BROCKMAN RESOURCES LIMITED

MARILLANA IRON ORE PROJECT

**SUPPLEMENT TO RESPONSE TO PUBLIC
SUBMISSIONS**

EPA ASSESSMENT NO. 1781

² Batini, F. (2009) *Eucalyptus victrix*, Karinjini National Park. Report to Environmental Protection Authority

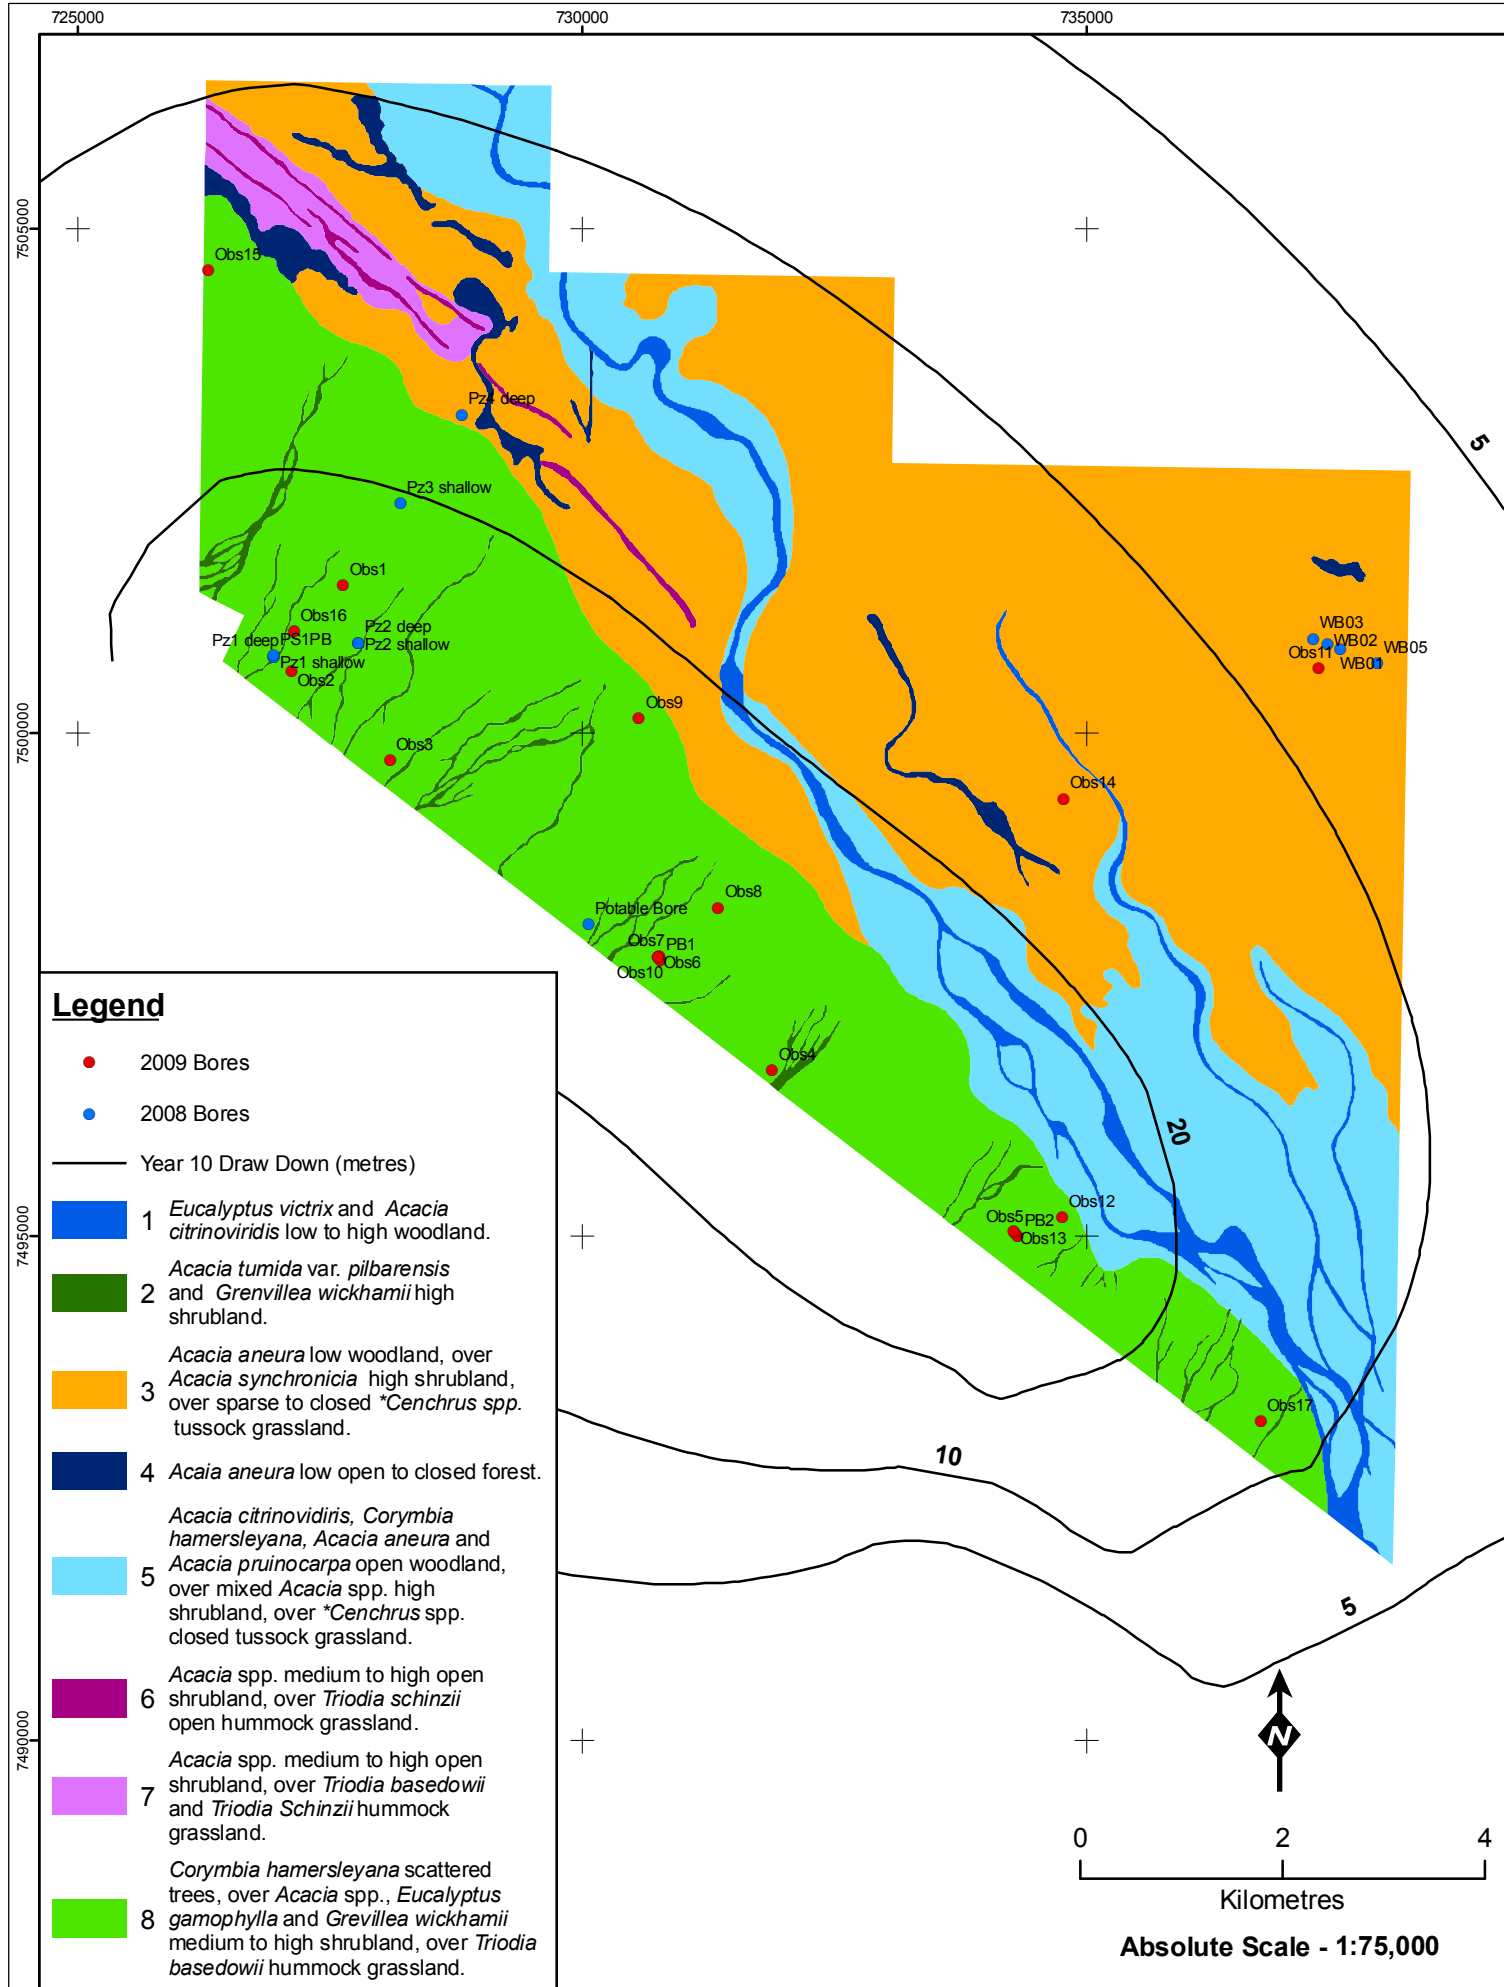
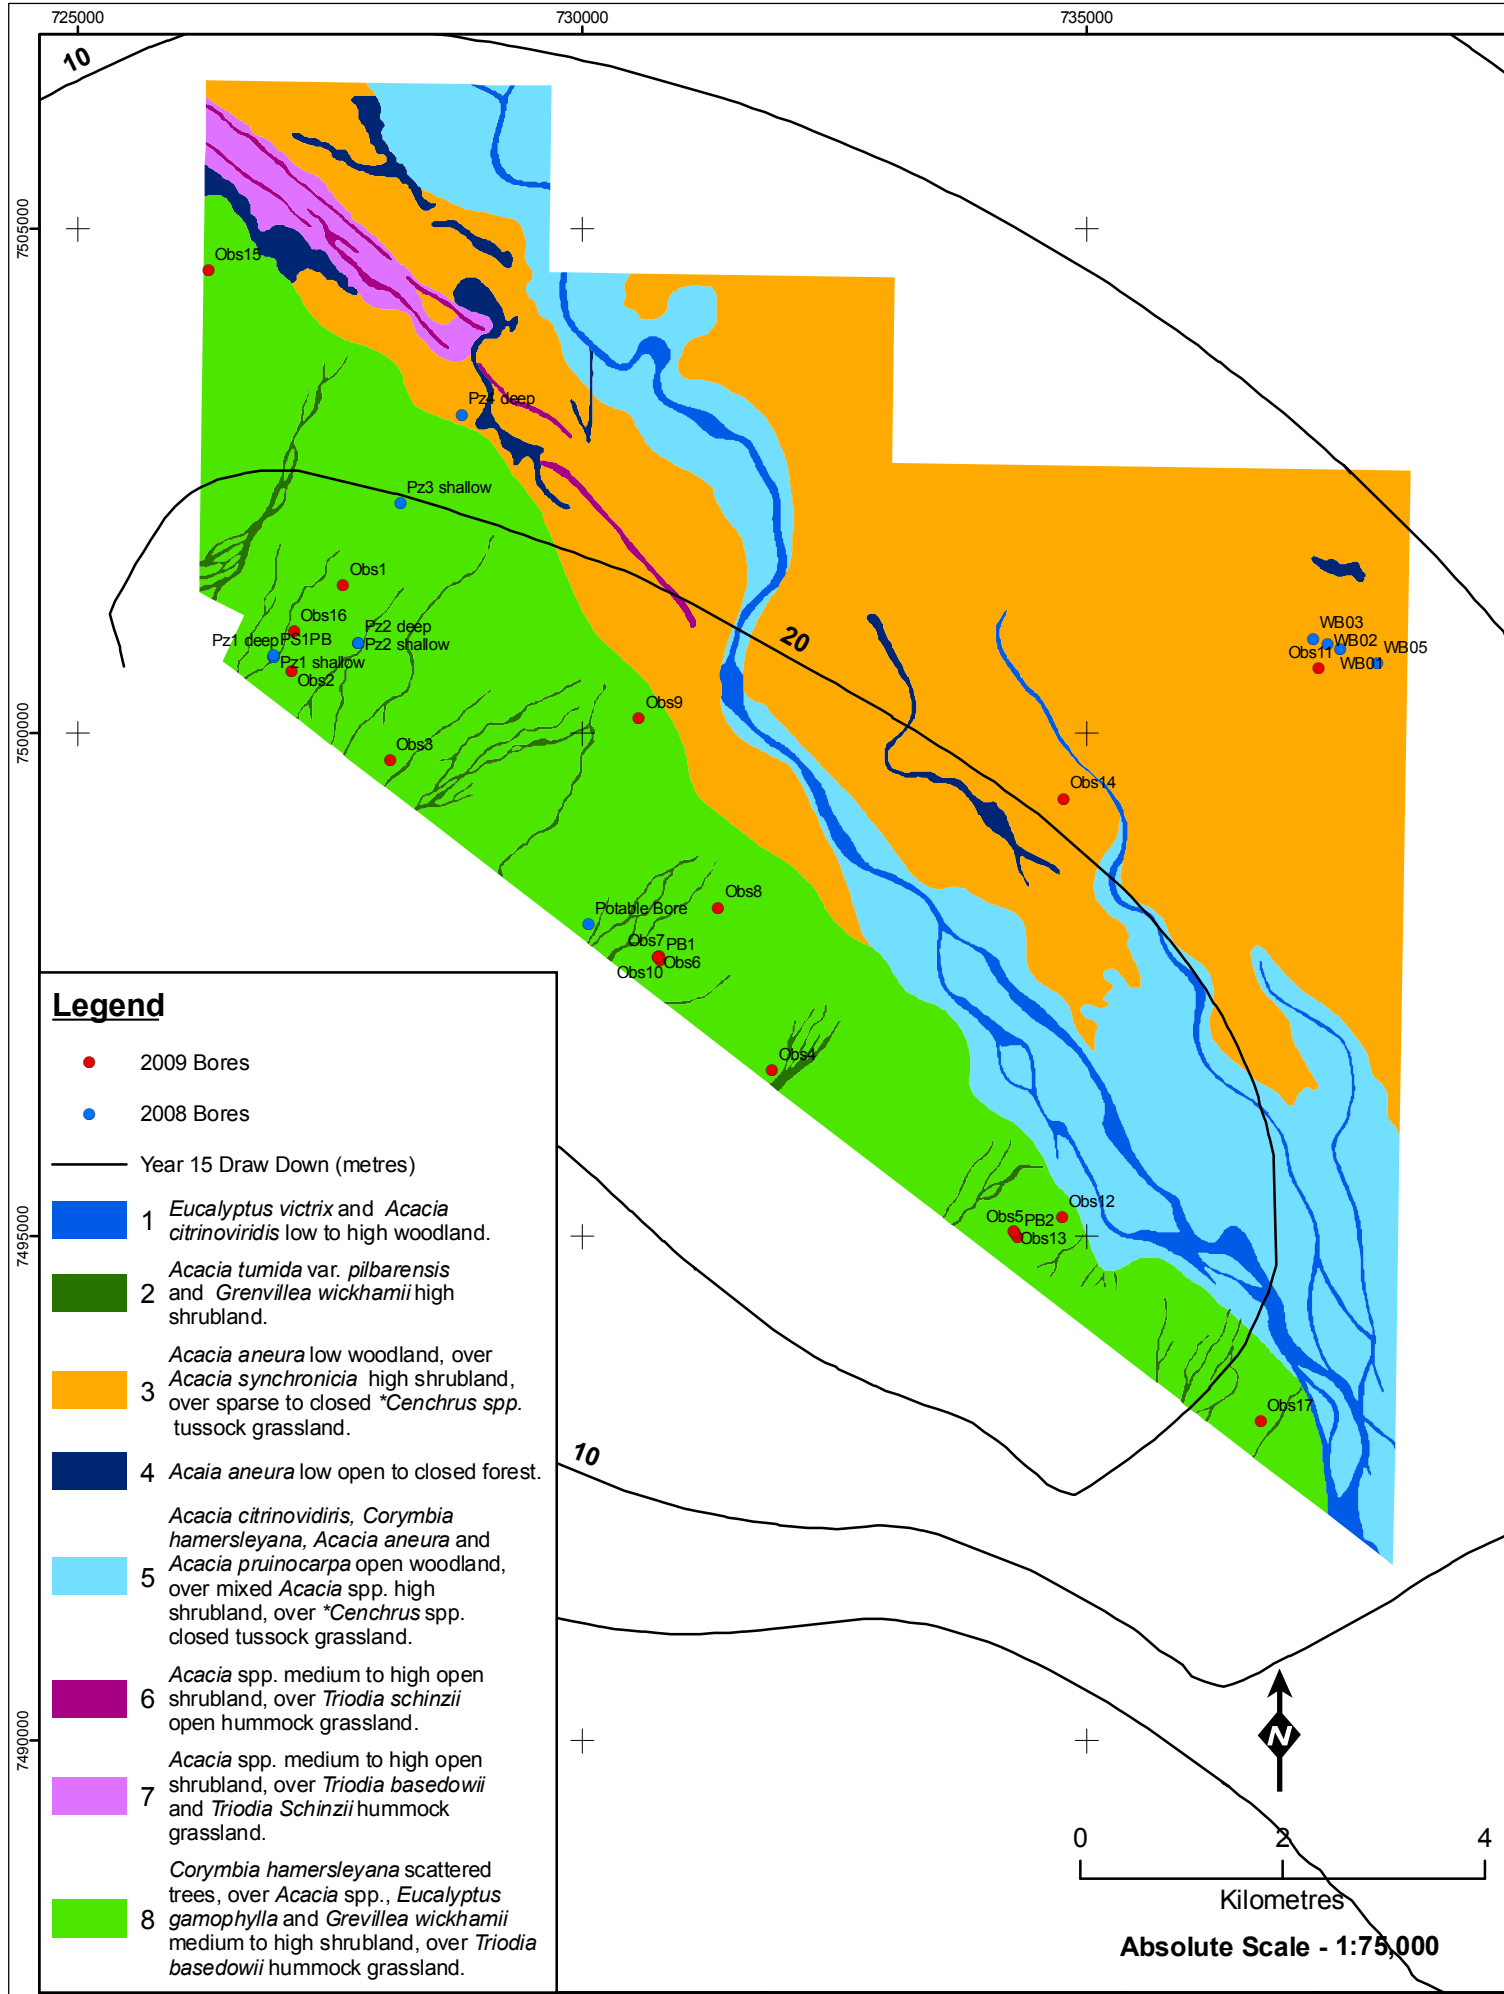
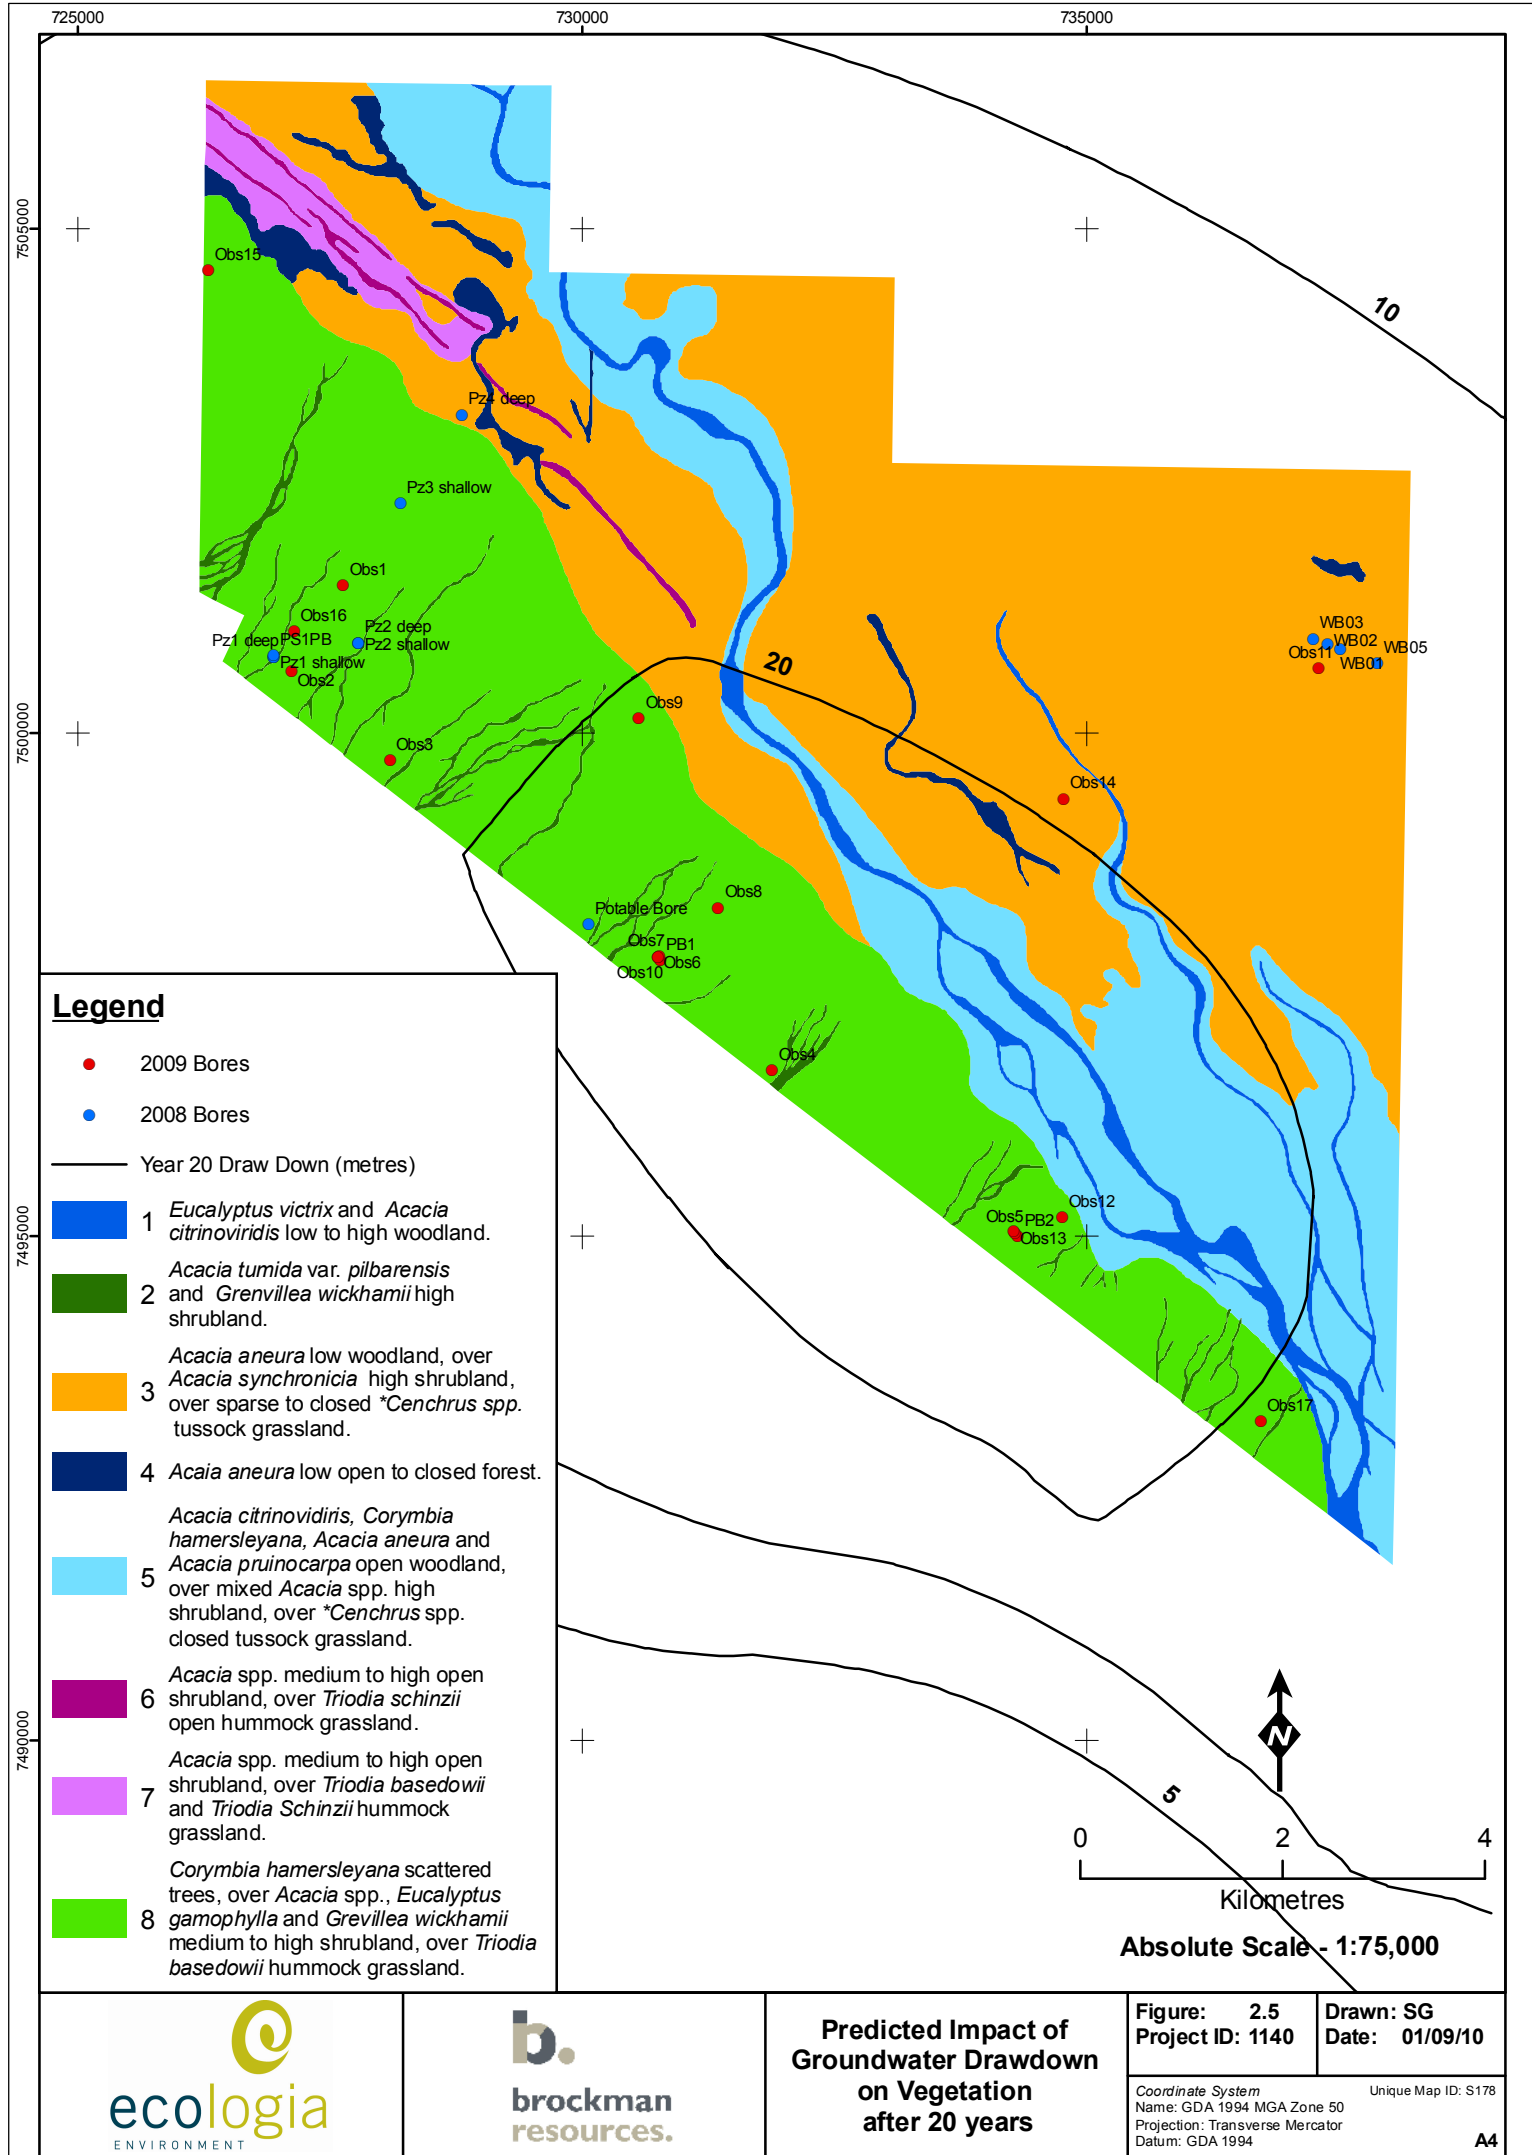
Please provide further details regarding management and monitoring actions proposed in relation to groundwater dependant vegetation. This should include:

- Clear spatial identification of any GDE which could potentially be impacted by the proposal;
- An outline of the proposed monitoring programme for GDE's including methodology and schedule;
- Criteria and trigger values to be assessed by the monitoring program; and
- Contingency actions to be taken in the event that trigger levels are exceeded.

Groundwater levels in relation to vegetation types across the Marillana site are shown in Figure 2.1. As identified in Section 6.7 of the PER, two sub-units containing one potentially phreatophytic species, *Eucalyptus victrix*, were recorded within the survey area

The predicted impact of groundwater drawdown on vegetation over the 20 year mine life is shown in Figures 2.2 – 2.5. The drawdown is at a maximum of 40 m below pre mining levels in the western end of the orebody to facilitate dry mining conditions and reduces with distance from the main pit area. Whether the extent of the drawdown proposed is likely to significantly affect the potentially phreatophytic vegetation lining the Weeli Wolli Creek is yet unknown, given the predicted natural variability in groundwater underneath the creek.

At the end of the 20 year mining period, the 20 m drawdown extends 8 km across the Weeli Wolli Creek. The 10 m drawdown extends across the remainder of the Weeli Wolli creek to just beyond the tenement boundary. The current water table in within the drawdown zone varies between 18 to 30 m. Brockman has a drilling program underway on the Marillana tenement to investigate the interaction between surface water flows and groundwater near Weeli Wolli Creek. This will provide further information to be fed into the Phreatophytic Vegetation Monitoring Plan and results (see Section 2.1.2 below).
